dsPIC33EPXXGS50X Family Silicon Errata and Data Sheet Clarification

The dsPIC33EPXXGS50X family devices that you have received conform functionally to the current Device Data Sheet (DS70005127D), except for the anomalies described in this document.

FIGURE 1: EXAMPLE FOR REDUNDANT OUTPUT MODE

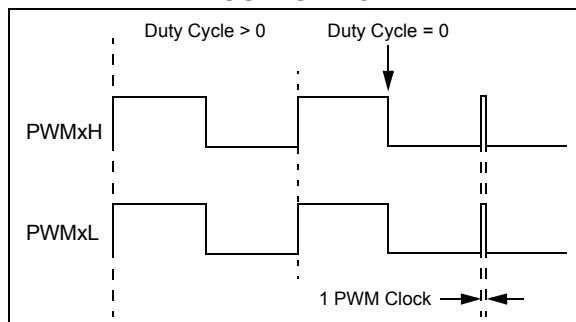
In the Redundant Output mode (IOCONx[11:10] = 0b01) and Push-Pull Output mode (IOCONx[11:10] = 0b10), with the Immediate Update Enable bit disabled (PWMCONx[0] = 0), when the Duty Cycle register is updated from a non-zero value to zero, a glitch pulse of a width equal to one PWM clock will appear at the next PWM period boundary, as shown in Figure 1 (for the Redundant Output mode). The Duty Cycle register refers to the PDCx register if PWMCONx[8] = 0 or the MDC register if PWMCONx[8] = 1.

If the application requires a zero duty cycle output, there are two possible work around methods:

1. Use the PWM override feature to override the PWM output to a low state instead of writing to the Duty Cycle register. In order to switch back to a non-zero duty cycle output, turn off the PWM override. The override-on and override-off events must be timed close to the PWM period boundary if the IOCONx register has been configured with IOCONx[0] = 0 (i.e., output overrides through the OVDDAT[1:0] bits occur on the next CPU clock boundary).
2. Enable the Immediate Update Enable bit (PWMCONx[0] = 1) while configuring the PWMx module (i.e., before enabling the PWMx module, PTCON[15] = 1). With the Immediate Update enabled, writes to the Duty Cycle register can have an immediate effect on the PWM output. Therefore, the duty cycle write operations must be timed close to the PWM period boundary in order to avoid distortions in the PWM output.

FIGURE 2:

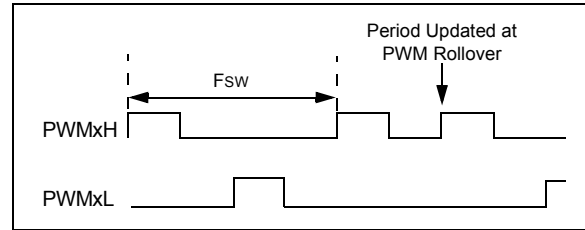
When the PWM module is configured for Push-Pull mode (IOCONx[11:10] = 0b10) with the Enable Immediate Period Update bit enabled (PTCON[10] = 1), a write to the Period register that coincides with the period rollover event may cause the push-pull output logic to produce back-to-back pulses on the PWMx pins (Figure 2).

Ensure that the update to the PWM Period register occurs away from the PWM rollover event by setting the EIPU bit (PTCON[10] = 1). Use either the PWM Special Event Trigger (SEVTCMP) or the PWM Primary Trigger (TRIGx) to generate a PWM Interrupt Service Routine (ISR) near the start of the PWM cycle. This ISR will ensure that period writes do not occur near the PWM period rollover event.

FIGURE 3: MISMATCH OF WORKING REGISTER SET WHEN NESTING MORE THAN ONE INTERRUPT WITHIN INTERRUPTS THAT USE ALTERNATE WORKING REGISTER SETS

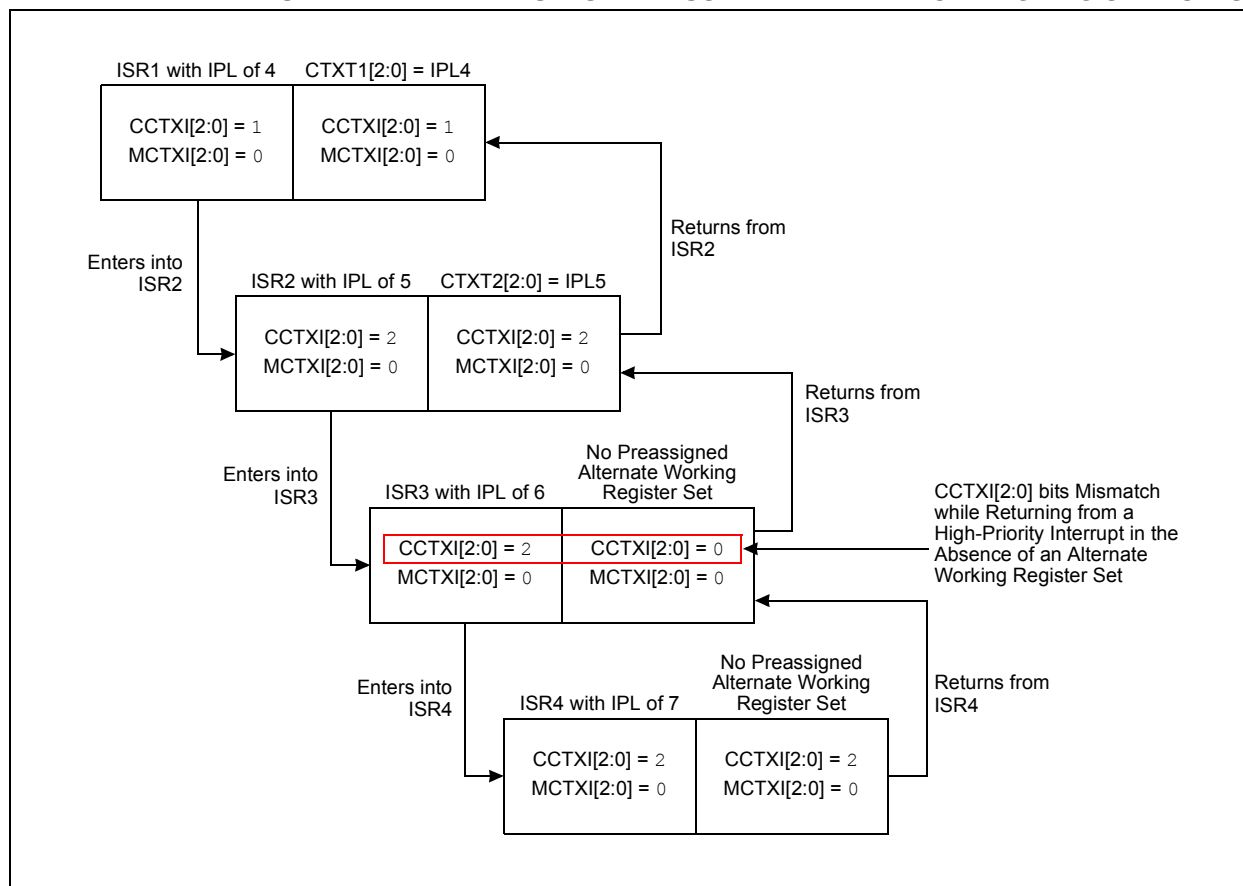
When returning from an Interrupt Service Routine (ISR) by executing the `RETFIE` instruction, in the case of a nested interrupt, the Interrupt Priority Control bits (`IPC[3:0]`) associated with the lower priority interrupt are compared with the `CTXTn` bits field in the `FLTREG` Configuration register:

When using interrupts with the Alternate Working Register Set (automatic context assignment), no more than one ISR without an Alternate Working Register Set must be nested within an ISR with an Alternate Working Register Set.

Issue and work around are illustrated in [Figure 3](#) and [Figure 4](#), respectively. The figures show the status bits, `CCTXI[2:0]` and `MCTXI[2:0]`, after entering into an ISR from a lower priority ISR (left pane), and after returning to the same ISR from a higher priority ISR (right pane).

FIGURE 5: SIMPLIFIED BEHAVIOR

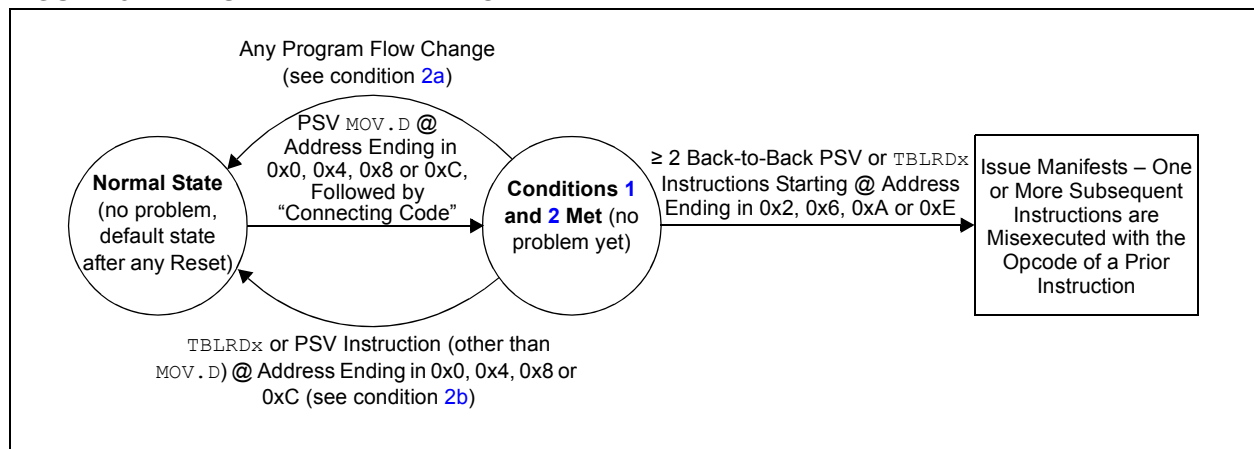
| 3. | ≥ 2 back-to-back PSV or <code>TBLRDx</code> instructions are executed (following the code of condition 2), where the first of the back-to-back instructions is located at an address ending in 0x2, 0x6, 0xA or 0xE. |

[Figure 5](#) provides an example of the effective behavior.

1. All instances of PSV `MOV.D` can be replaced with two PSV `MOV` instructions instead. Non-PSV `MOV.D` instructions acting on RAM/SFRs do not need to be modified; or
2. If not already present, a program flow change instruction (such as `BRA $+2`) can be inserted above back-to-back data Flash read sequences; or
3. Back-to-back data Flash read instruction sequences can be broken up by inserting a non-Flash read instruction (such as a `NOP`), in between the Flash read instructions; or
4. The alignment of the code can be shifted to avoid the required opcode location addresses.
